Process Memorandum to File

Clarification of Perceived Discrepancies in Water Balance Data

**Prepared by:
Chris Garrett
SWCA Environmental Consultants**

Resolution Copper Project Alt 2 and Alt 3 DEIS Water Balance - Entrainment

Ratio of cycloned sand to scavenger beach

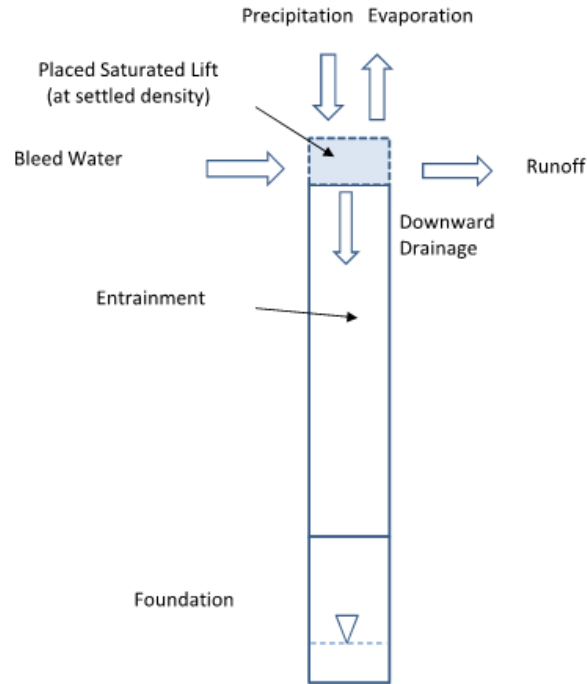
- Alt 2 – 4H:1V embankment slope, more cyclone sand, less tailings in beach
 - cyclone sand has lower m/c¹ than tailings beach, therefore less entrained water per ton of tailings
- Alt 3 – 3H:1V embankment slope, less cyclone sand, less tailings in beach
 - beach tailings have higher m/c than cycloned sand, therefore more entrained water per ton of tailings
- However, the difference in cyclone sand volumes does not account for the discrepancy alone

Alt 2 Seepage Estimate / Saturation

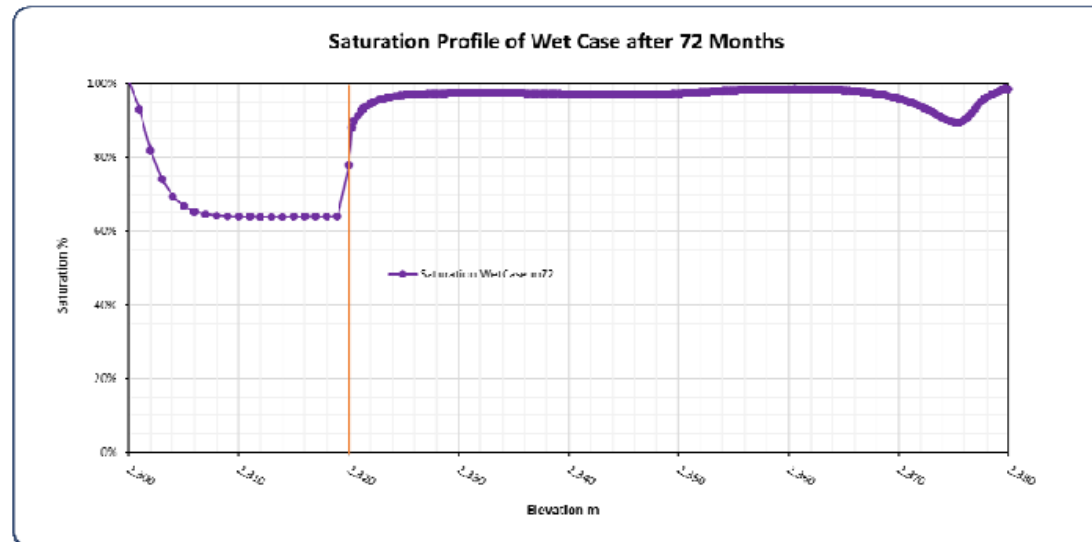
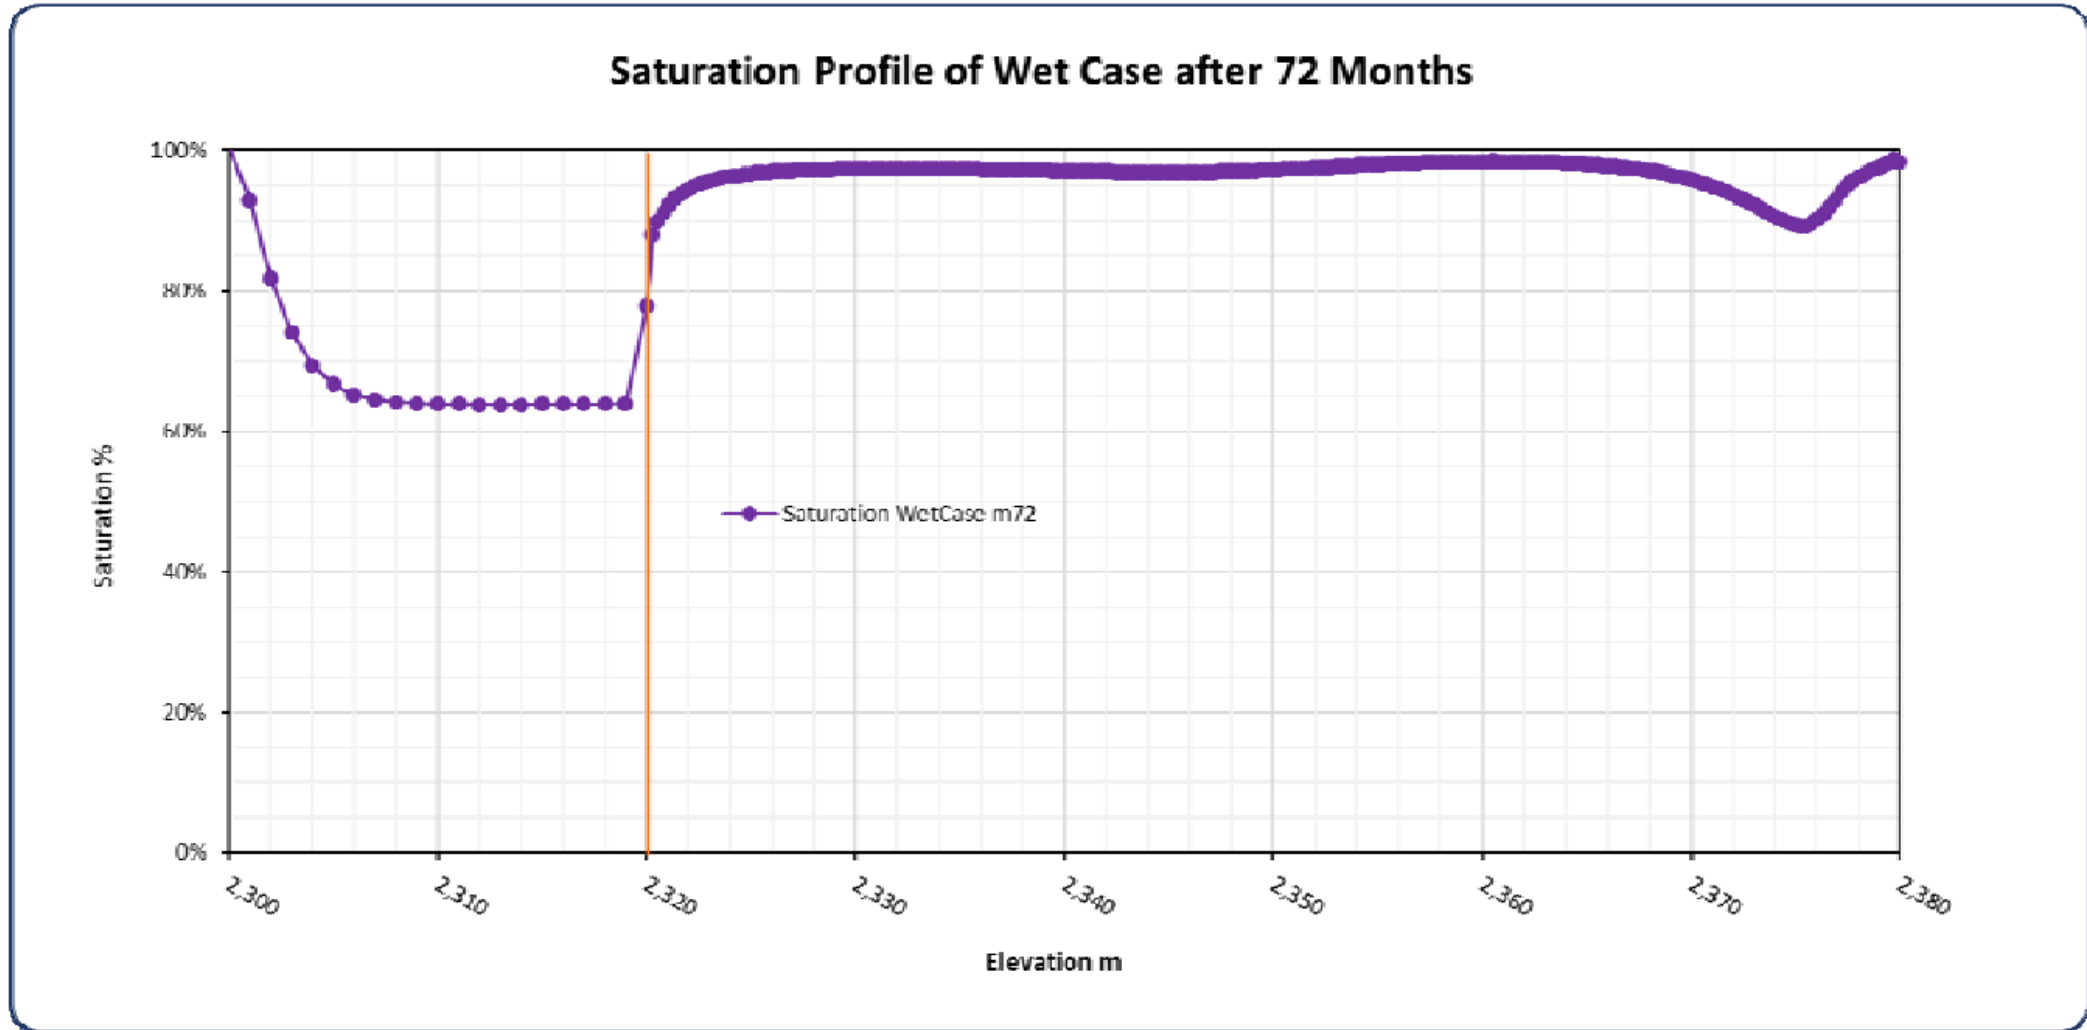
In order to estimate seepage from the tailings storage facilities, KCB constructed 1-dimensional column model for each alternative. Using the model, the percent saturation over time can be estimated and plotted (see Attachment 1). For Alternative 2, the model shows saturation remaining

close to 100 percent over most of the tailings thickness, whereas for Alternative 3 the saturation remains closer to 80 percent.
